Year 7 Monitoring Report

Hudson Property

DMS Project ID #: 95361
DMS Contract #: 004638
DWR Project #: 20140422
USACE Action ID# SAW-2012-01394

RE: Draft Year 7 Monitoring Report for Hudson Property – (DMS#: 95361) (Ecotone #1269)

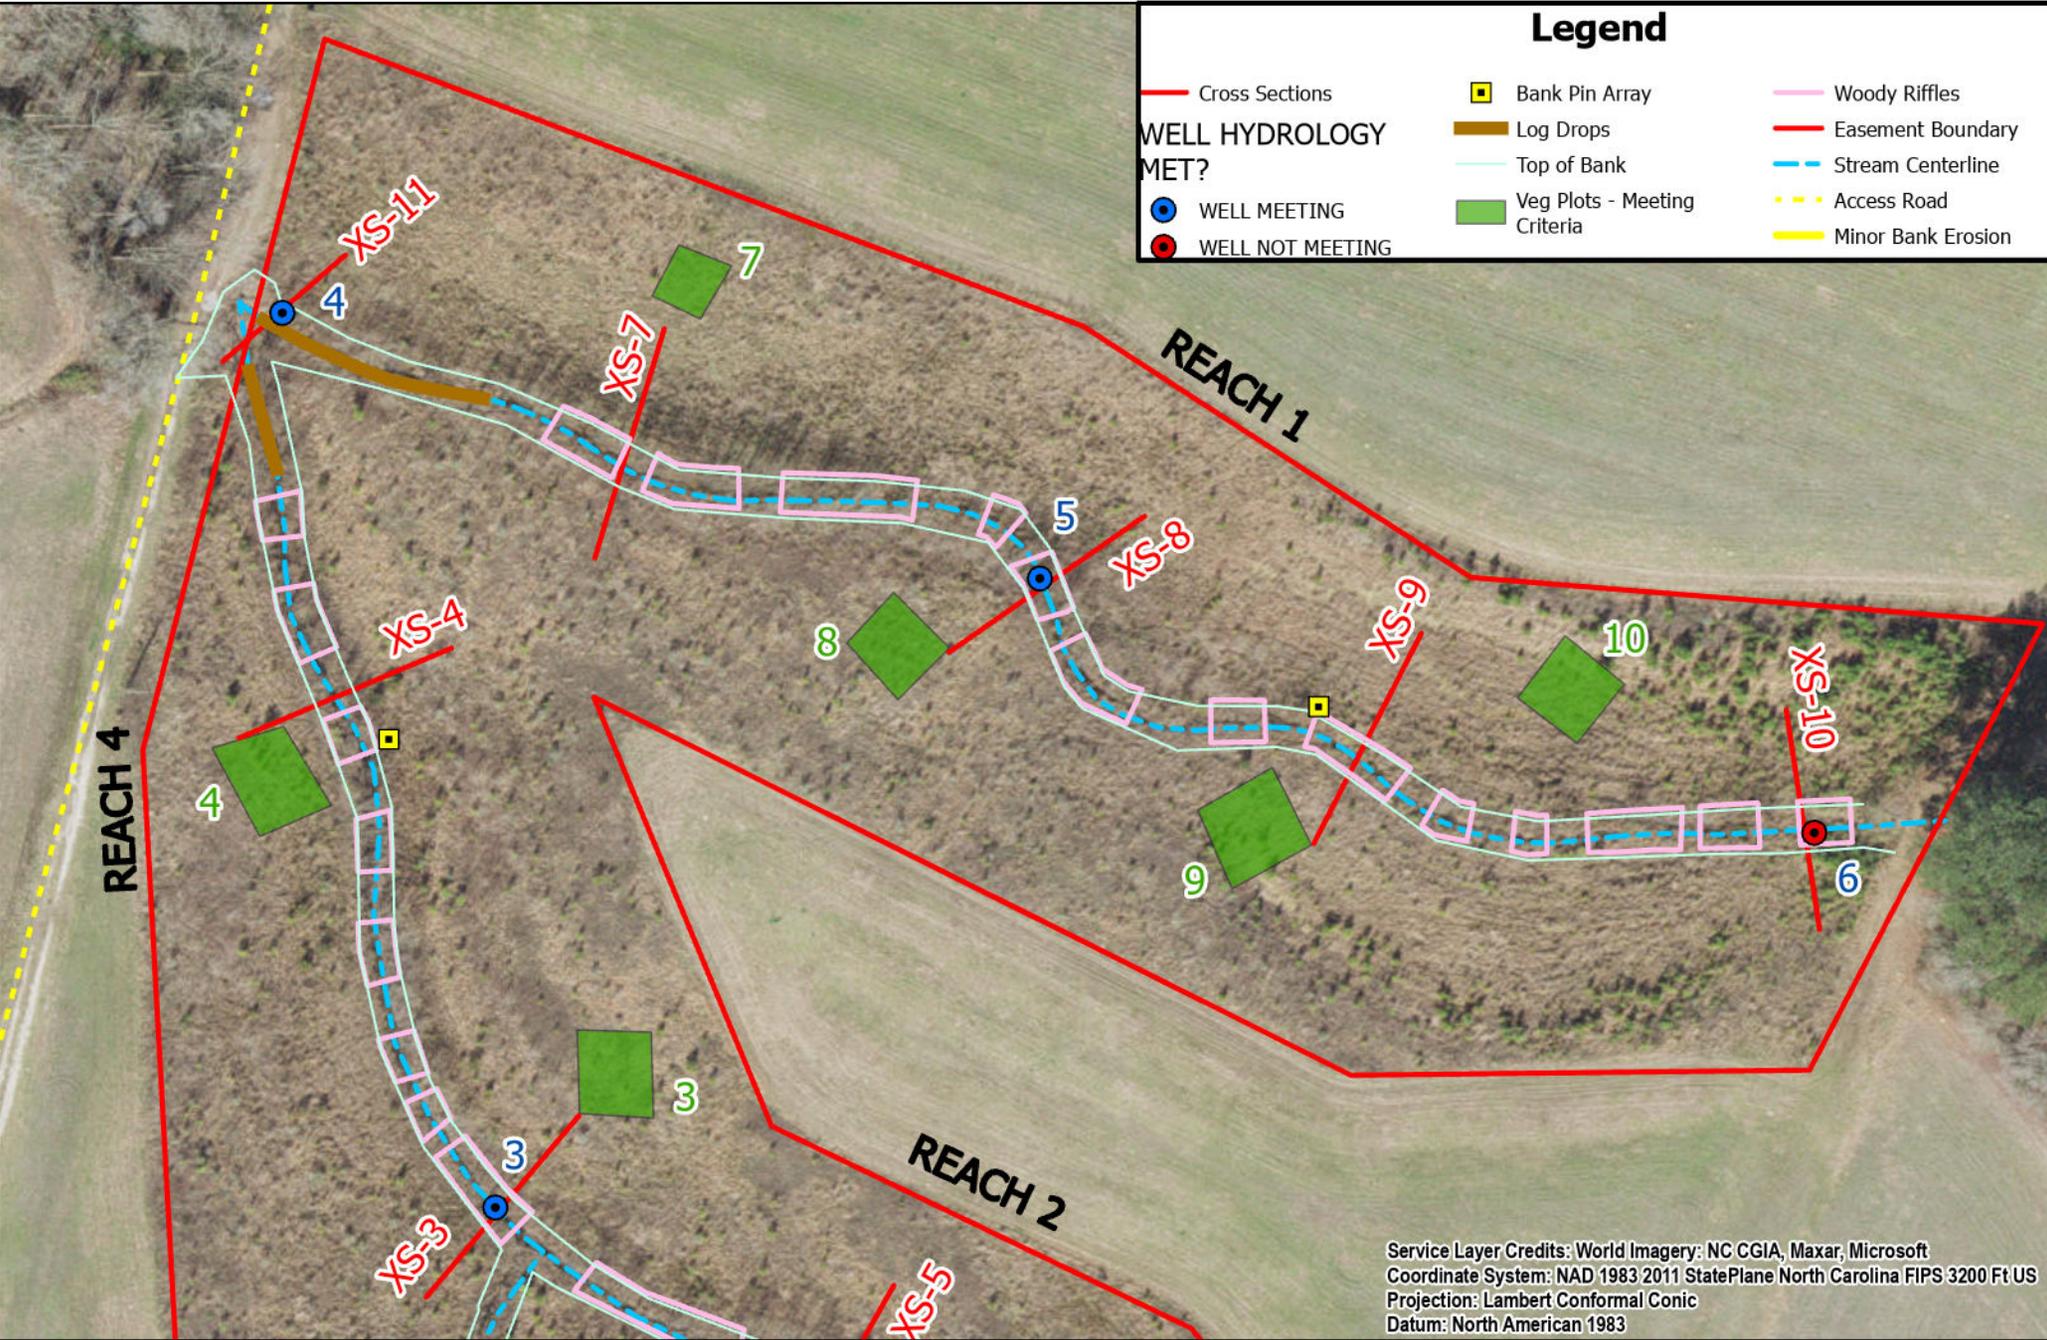
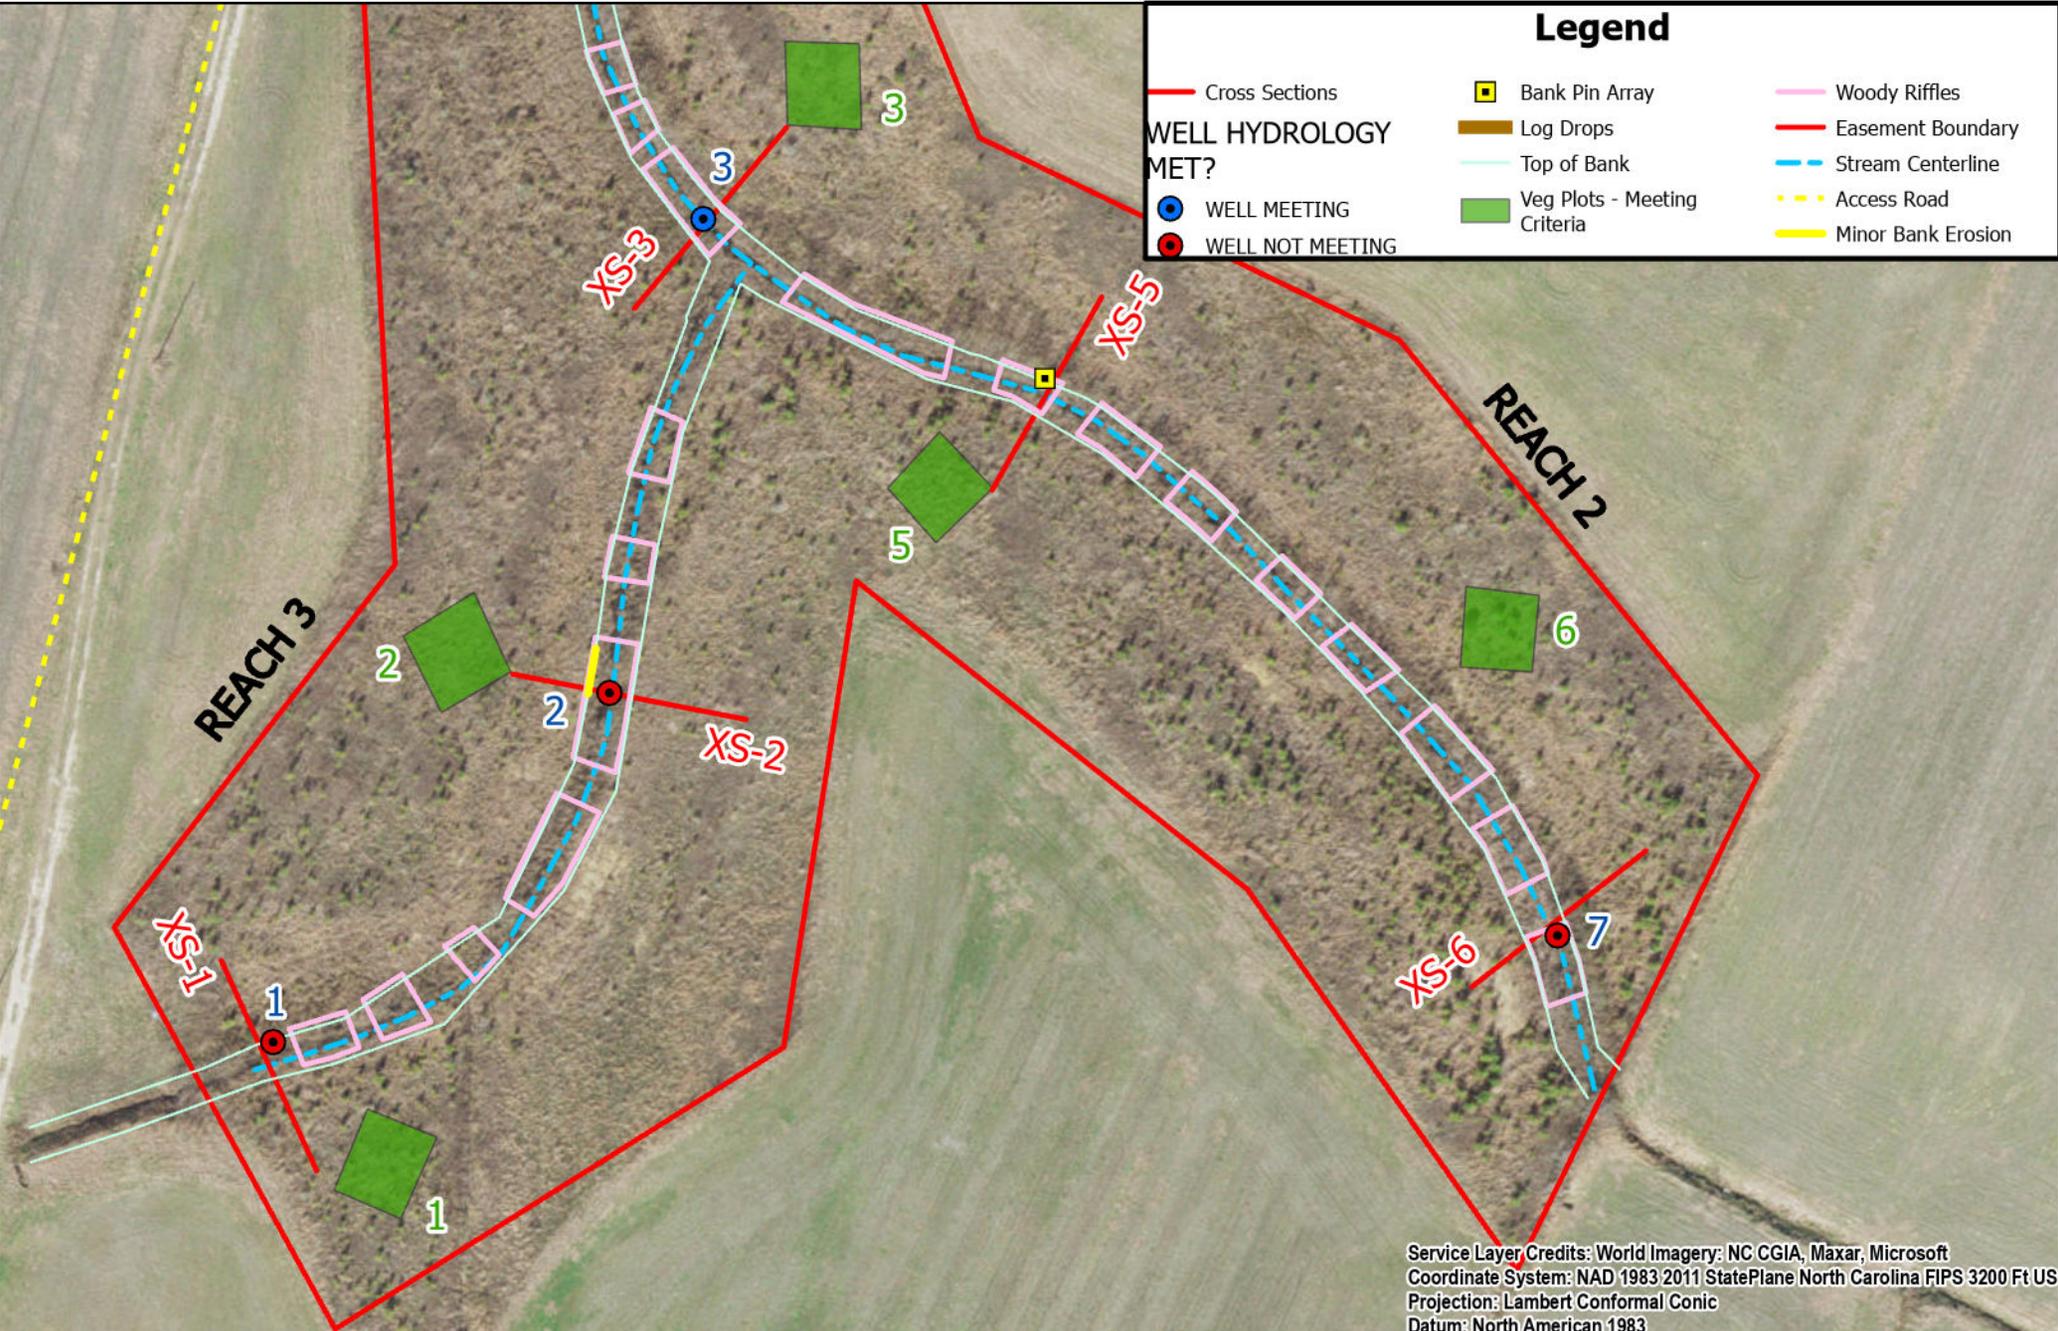
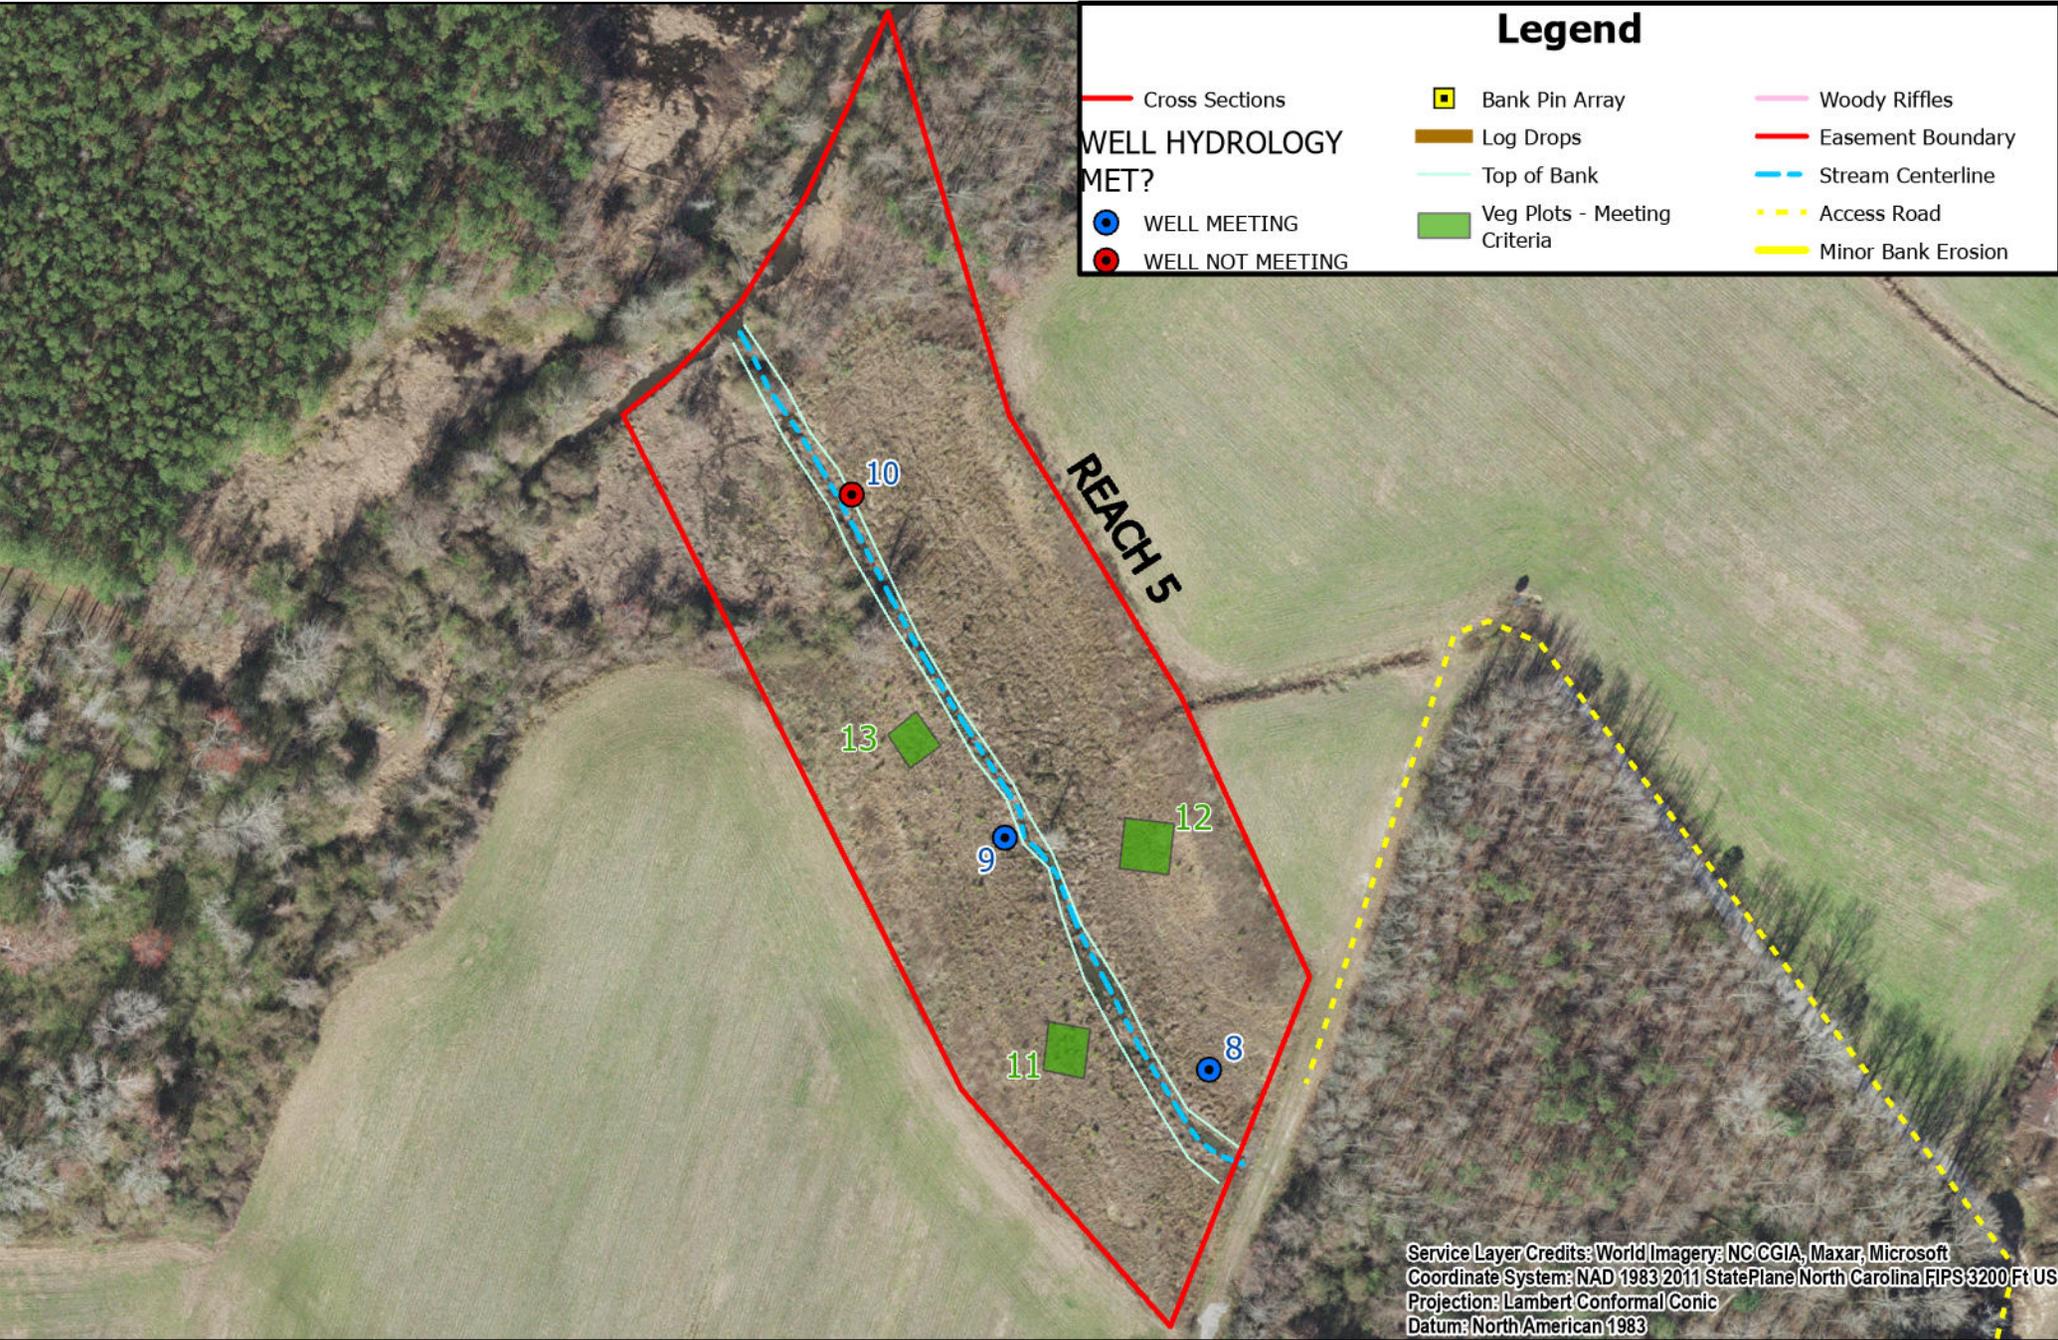
- On the CCPV, please show flow stations that malfunctioned as a different color or graphic and add to the legend.*
Ecotone Response: The wells are now color-coded to match their status.

10. *The Stream visual assessment table for reach 3 indicates 20 feet of scoured and eroded banks per the table, the submission was missing the required shapefile. This location needs to be indicated on the CCPV as well. If the area has been revegetated and/or repaired, or has not shown further signs of instability, please discuss briefly in Section 9.*
Ecotone Response: The shapefile has been added to the CCPV as a yellow line, as per the CCPV depiction for eroding banks.

Cross Section 6 – Reach 2 (2022 Data)

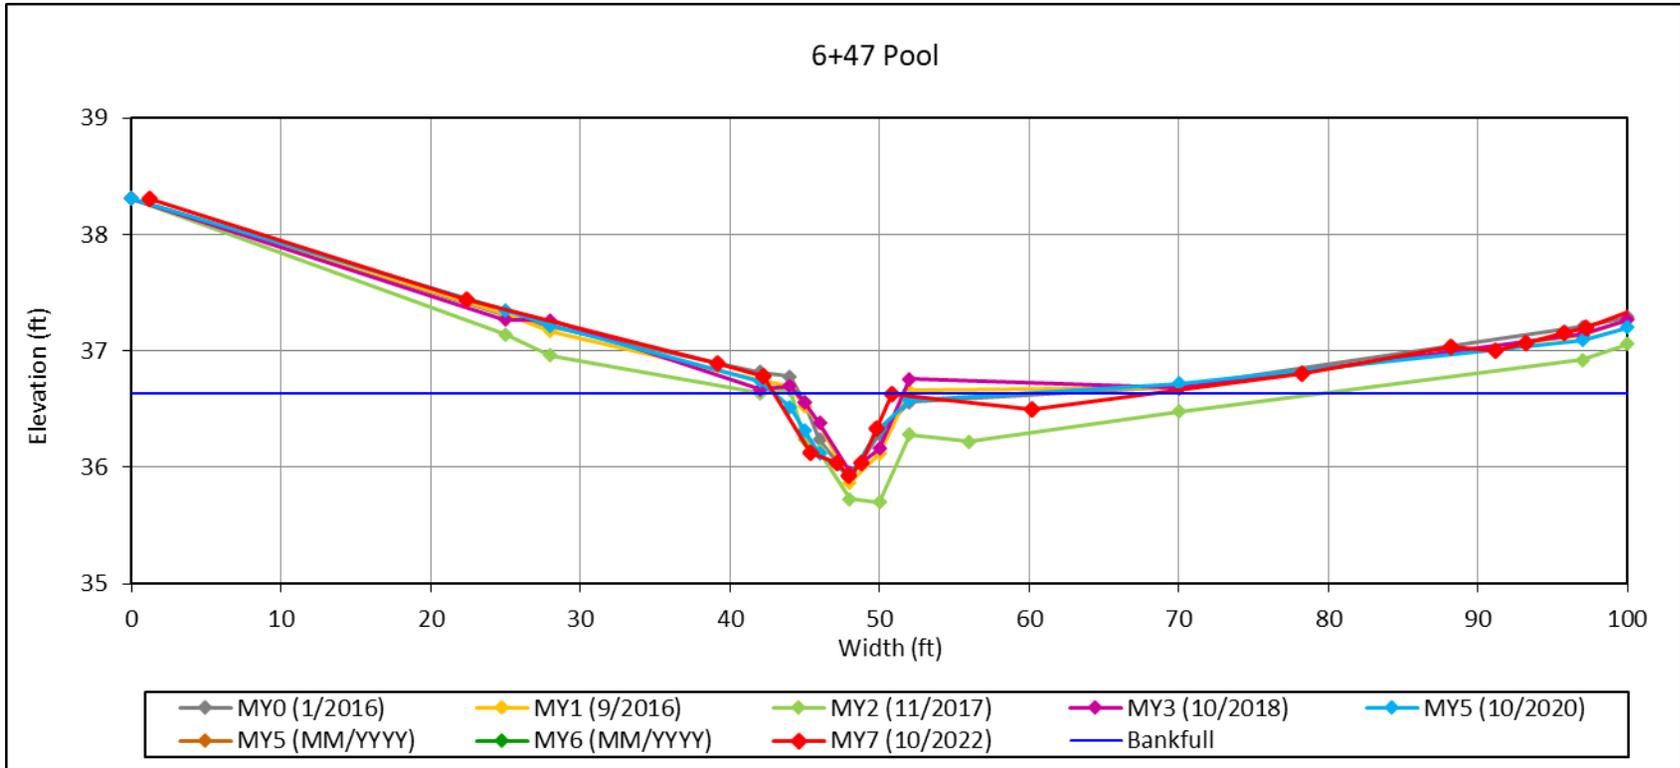
- In Table 11a, please verify the morphology data, specifically for XS6. The XS graph shows aggradation, and the max depth has decreased from 0.86 at AB to 0.60 in MY7, yet the LTOB cross sectional area is shown to have increased since MY0. Please verify or correct.*

- Ecotone Response: A revision was needed in the “omit bankful” checkbox of the survey overlay file. This slightly decreased LTOB Cross Sectional Area, though they are still higher than previous years. This is likely because aggradation has increased channel width. An arrow indicating the Year 7 LTOB has been added to the cross section 6 chart.

Cross Section 10 – Reach 1 (2022 Data)

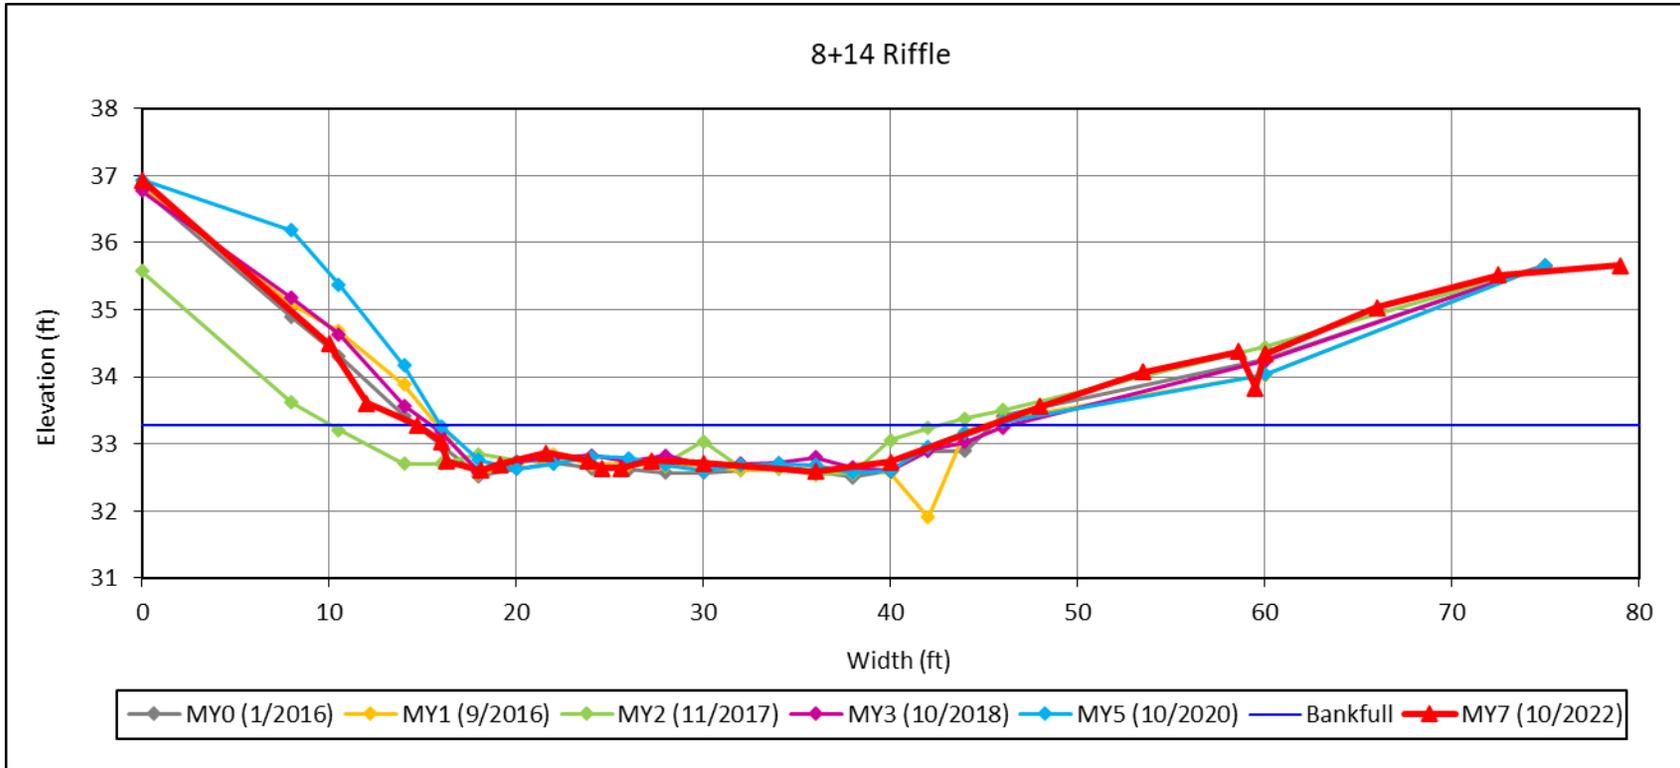
- Section 9 indicates that XS10 was moved 1 foot downstream. A cross section in the original location should still be completed, and the data/graph provided as normal. Any new, additional cross sections should be included as a separate graph (not overlain with years 0 – 6) with an explanation of what information is intended to be conveyed with the new data.*
Ecotone Response: Addressed in Section 9. Vegetation limited the ability to get laser level shots directly at the cross section.
